Appendix E

Responses to Comments on the Draft IS-MND

This section includes comments received during the circulation of the Draft Initial Study and Mitigated Negative Declaration (IS-MND) for the Medea Creek Restoration Project (SCH# 2015011008) and responses to those comments.

1 STAIRS - PLAN VIEW

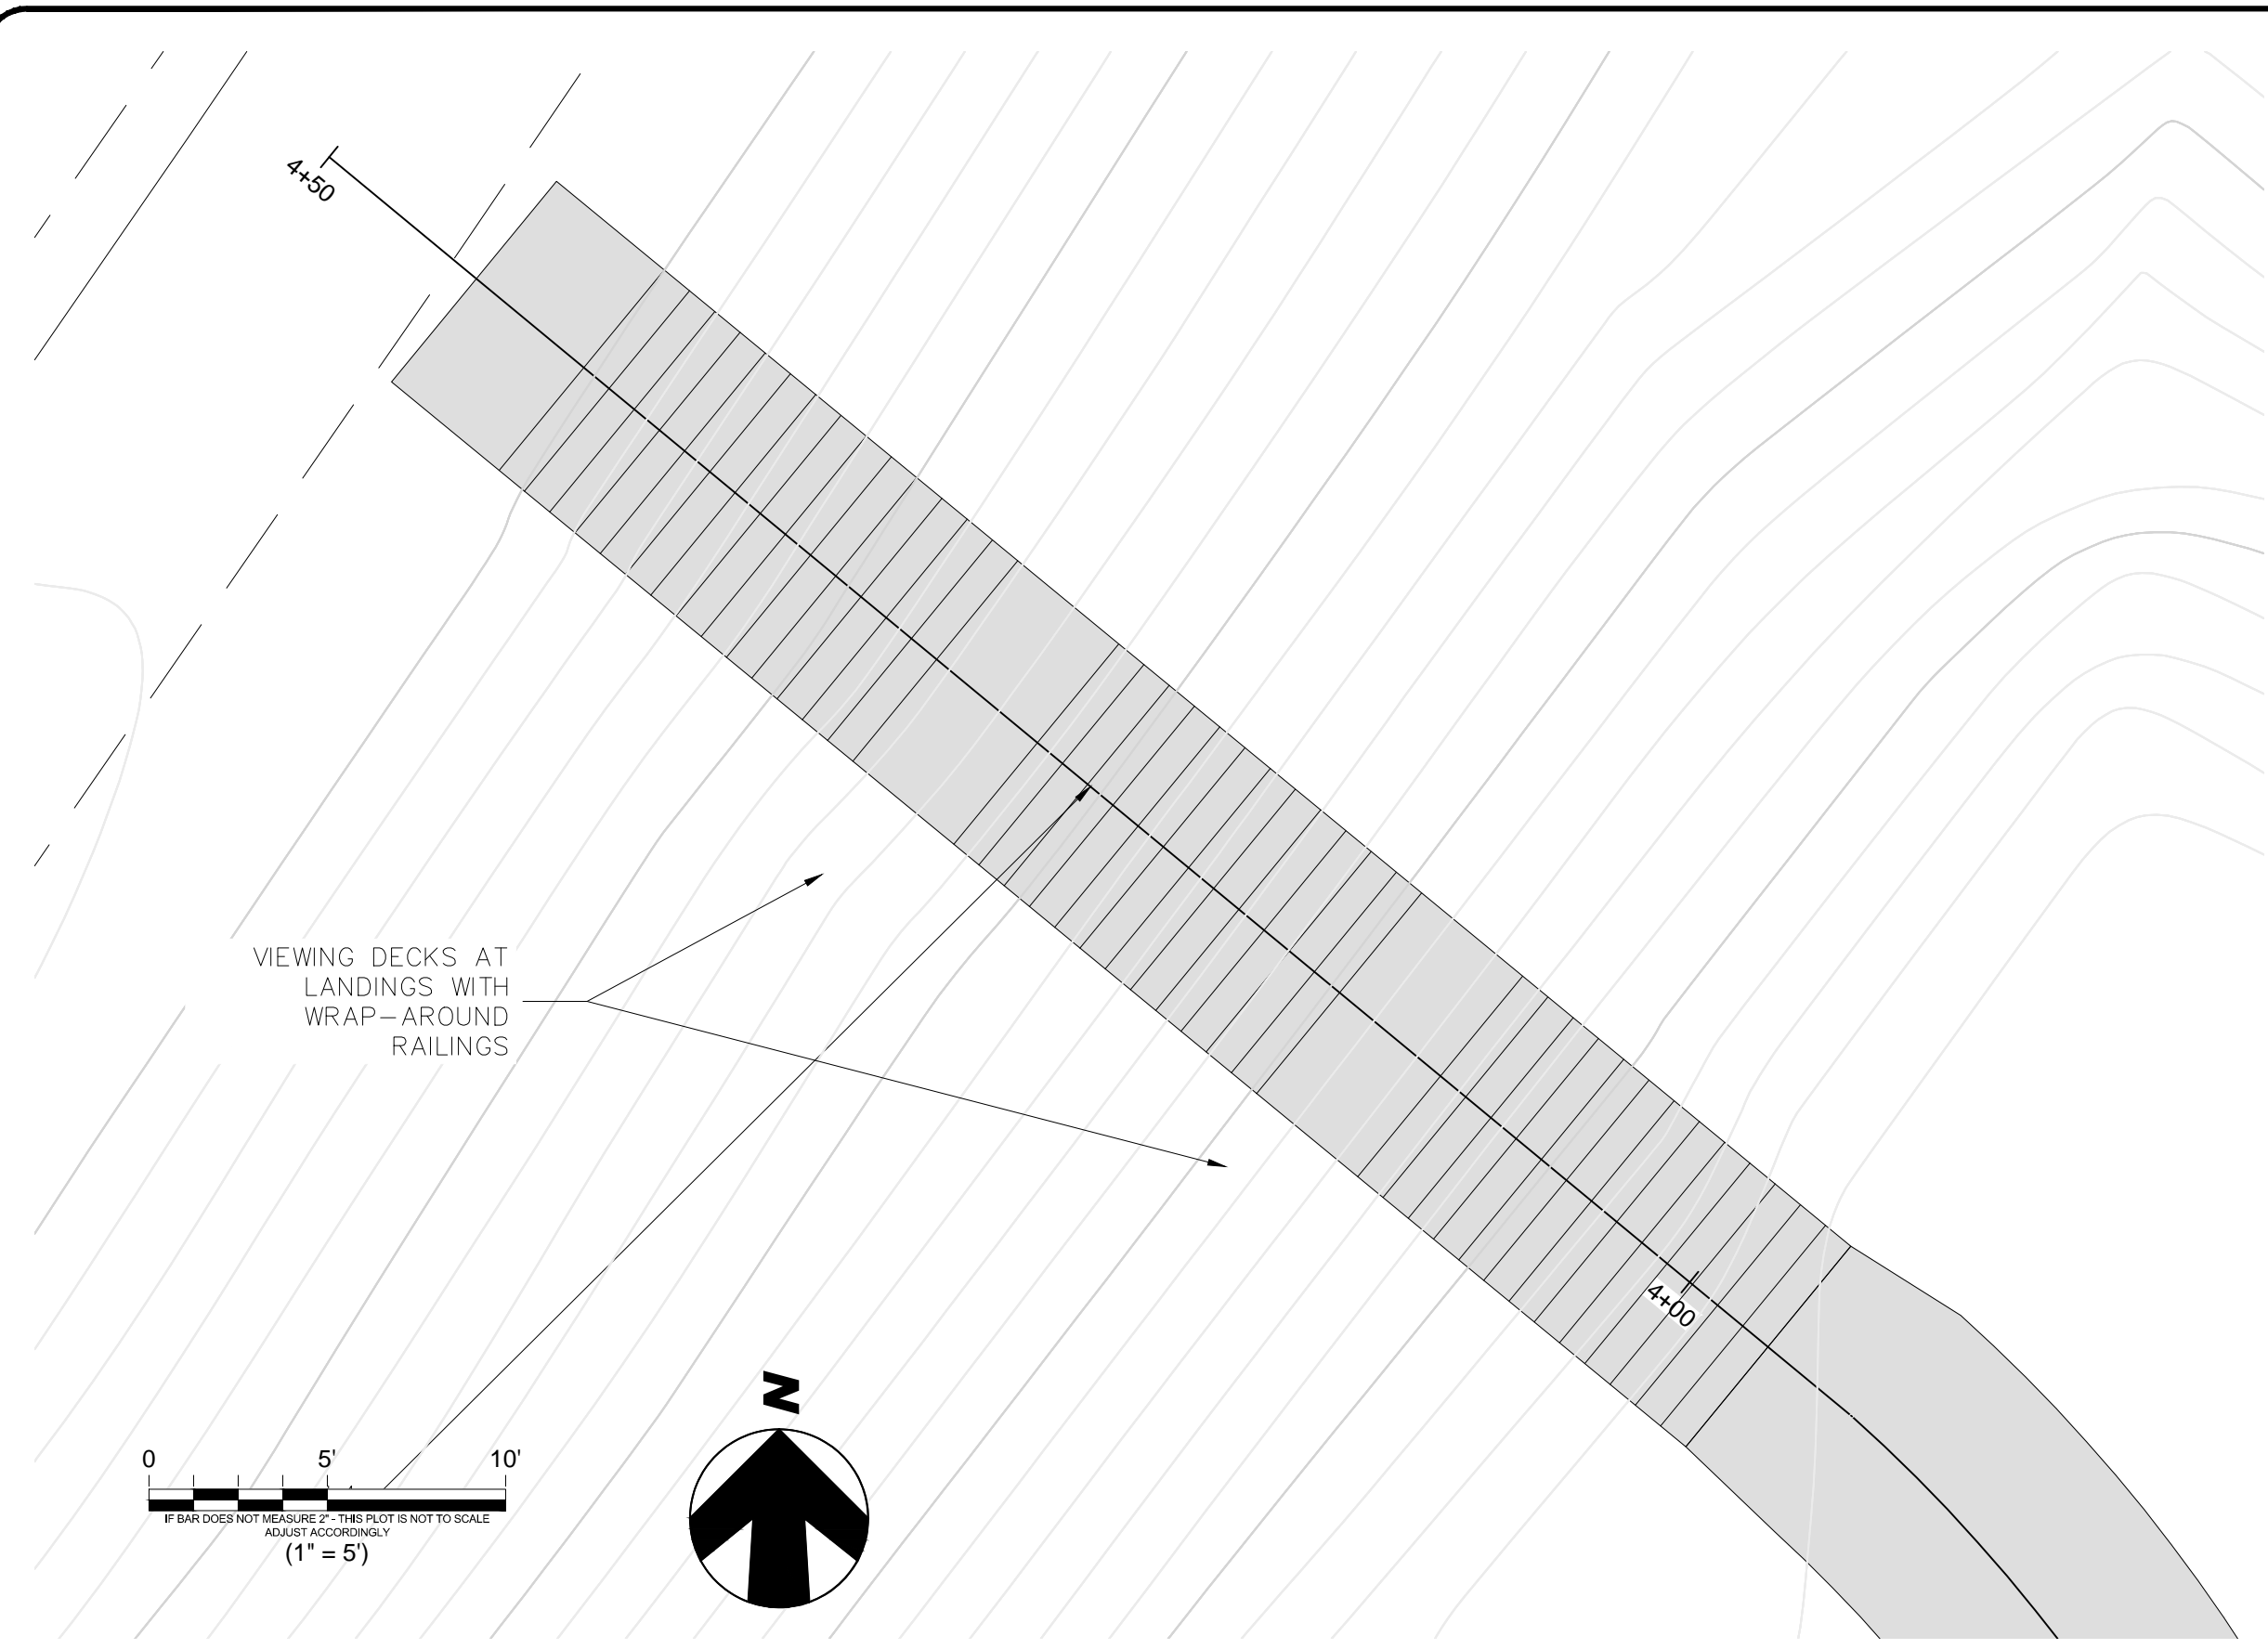
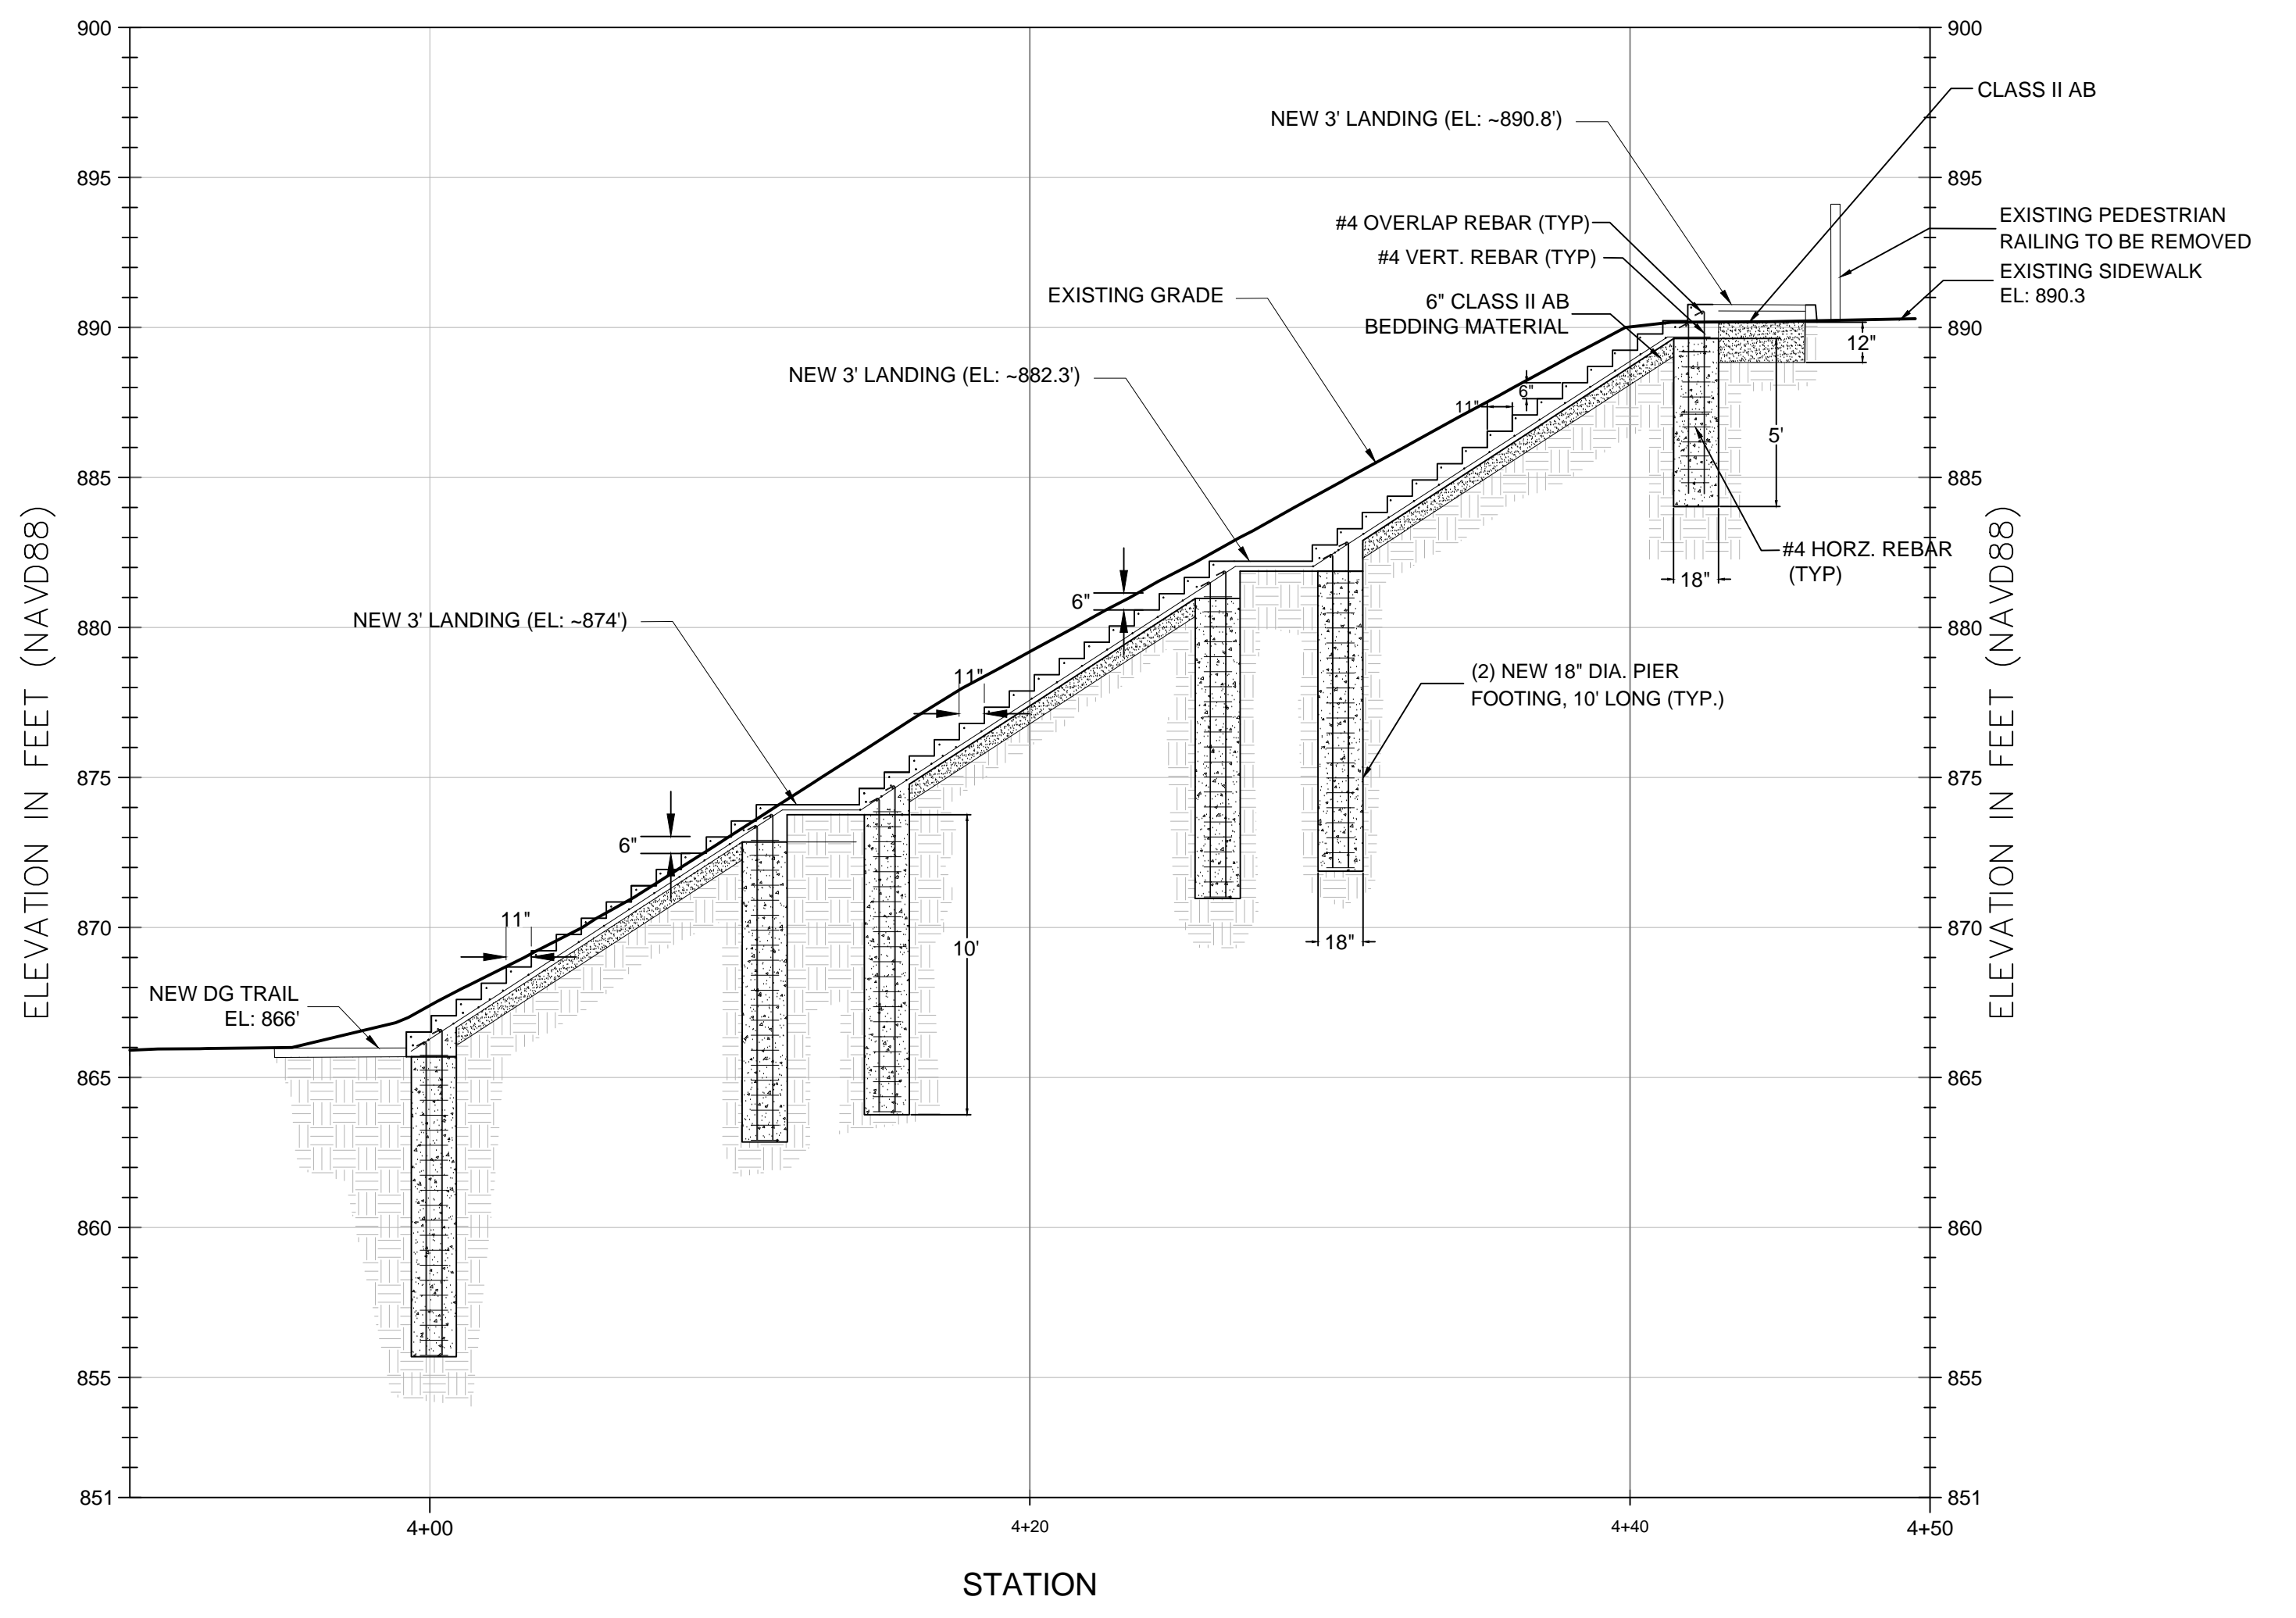
- 1) Add ramp alongside the stairway to Kanan. This ramp would be for bicyclists and the handicapped.
- 2) Along the northern side of the Annandale condos add a trail to intersect with the trail that already goes around the Chumash ball-field. This northern side is the least steep side with a gentle slope. This enables Annandale II condos to have easy access to this Media Creek Restoration Project.

- 1) Add ramp alongside the stairway to Kanan Road for bicyclists and handicapped users.
- 2) Along the northern side of the Annandale condos add a trail to intersect with the trail that currently is located around the edge of the Chumash ball-field.

The commenter's support for the proposed project is noted. Note that the slope on the eastern side of the project site where the stairs would connect the pedestrian pathway to Kanan Road precludes provision of an ADA-compliant ramp. However, an ADA compliant trail is provided as part of the proposed project and could also be used by cyclists. The proposed 12-foot wide ADA compliant trail on the west side of the channel would connect Kanan Road to Chumash Park via a pedestrian bridge. See Sheet 9 of the preliminary construction drawings included in Appendix D for further detail.
